ENVIRONMENTAL PROTECTION AGENCY

40 CFR Part 63

National Emission Standards for Hazardous Air Pollutants for Source Categories: Organic Hazardous Air Pollutants From the Synthetic Organic Chemical Manufacturing Industry and Other Processes Subject to the Negotiated Regulation for Equipment Leaks

ACTION: Proposed rule; amendments.

Figure 1. ALTERNATIVE EXPERIMENTAL METHODS FOR DETERMINING THE FRACTION OF ORGANIC COMPOUND BIODEGRADED (Fbio) IN A BIOLOGICAL TREATMENT UNIT

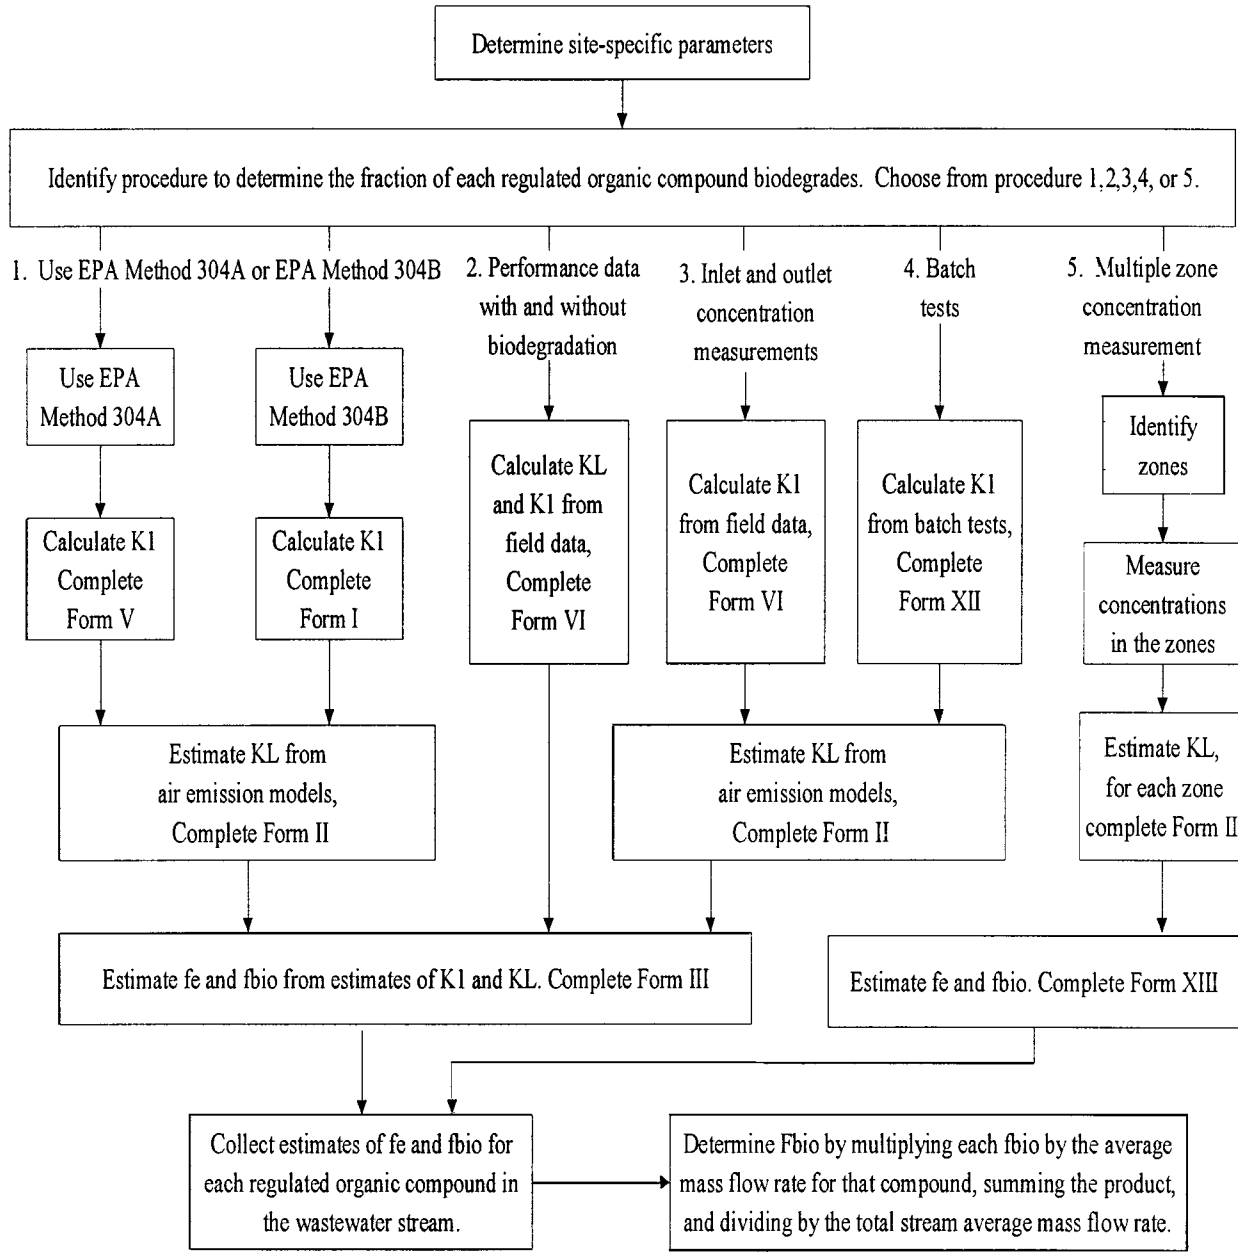
The purpose of adding this new procedure, called Multiple Zone Concentration Measurements, to appendix C is to provide an alternative concentration measurement test that can be used for units with multiple zones of mixing. The present concentration measurement procedure in appendix C, called the Inlet and Outlet Concentration Measurement Procedure, can only be used for thoroughly mixed treatment units. To use this new multiple zone procedure, you would identify zones with substantially uniform characteristics and would measure representative organic compound concentrations within the biological treatment unit as well as the inlet and outlet of the biological treatment unit. The estimated mass transfer coefficient for each compound is determined using the characteristics of each zone. You calculate f_{bio} for each compound and each zone using Form XIII.

- 23. Appendix C to part 63 is amended by:
 - a. Revising the third paragraph in section I;
 - b. Revising the introductory text to section III;
 - c. In section III.D.1, revising Eqn App.C–4 and the paragraph preceding it;
 - d. In section III.D.2, revising Eqn App.C–6 and the paragraph preceding it;
 - e. Adding section III.E;
 - f. Adding references 7 and 8 to the References section;
 - g. Revising Figure 1;
 - h. Adding Form XIII.
